DEVELOPMENT REVIEW COMMITTEE (DRC) COMMENT REPORT

PROJECT NAME: Anointed By Christ International Christian Center

CASE NUMBER: R19018

REQUEST: Site Plan Level III Review: Conditional Use for House of Worship

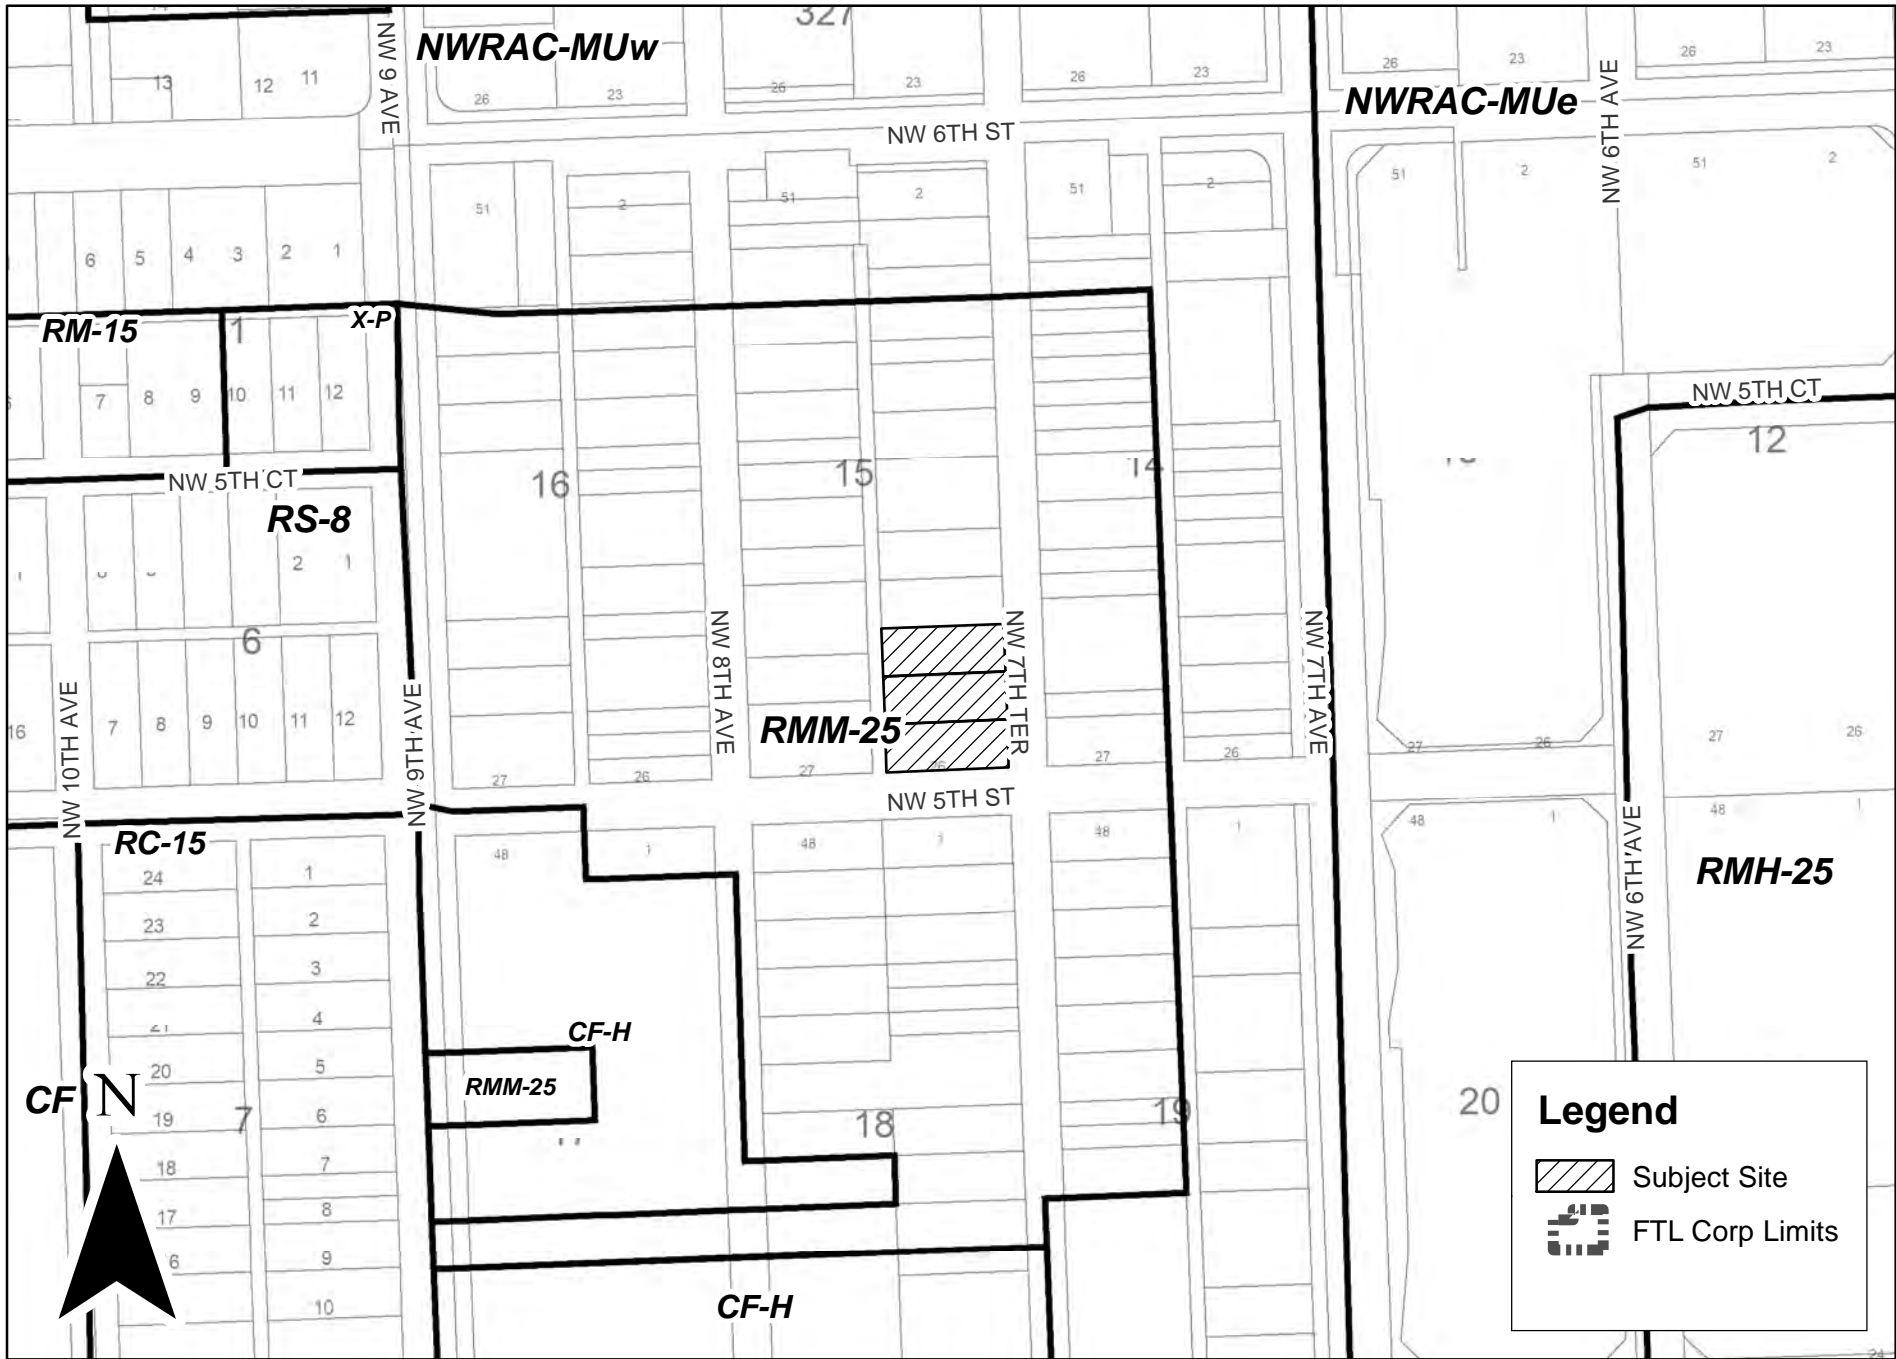
30. The City owns and maintains stormwater infrastructure adjacent to the proposed development as shown with green line work in the map provided at the end of this report. Please revise labels to match the labels shown at the end of this report.
